CUSTOMER NOTIFICATION

SUD-DT-04-0094 (1/11)
March 5, 2004
Yoshiro Harada, Senior System Integrator Microcomputer Group 2nd Solutions Division Solutions Operations Unit NEC Electronics Corporation

**IE-78K0K1-ET**  
**(Control Code: A, B, C)**

**Operating Precautions**

### No.1 LED3 (POC RESET)

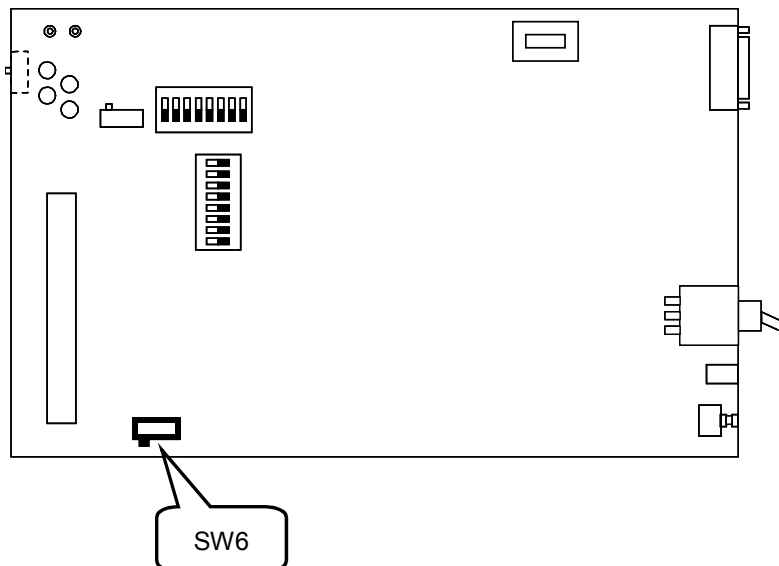
LED3 (POC RESET) is lit during the reset shown below. Do not perform a break when LED3 is lit; otherwise the integrated debugger ID78K0-NS will hang up.

- Internal reset by comparing the power supply voltage and detection voltage of the POC circuit

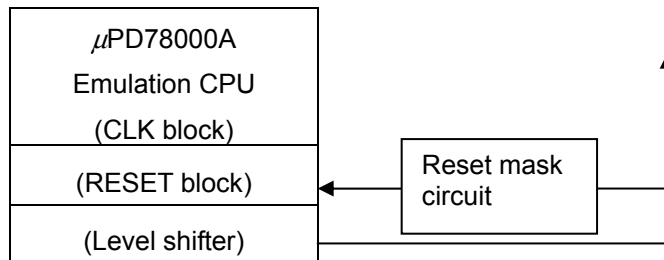
(12) Addition of 78K0/KF1+ to target devices

[Location] Page 51
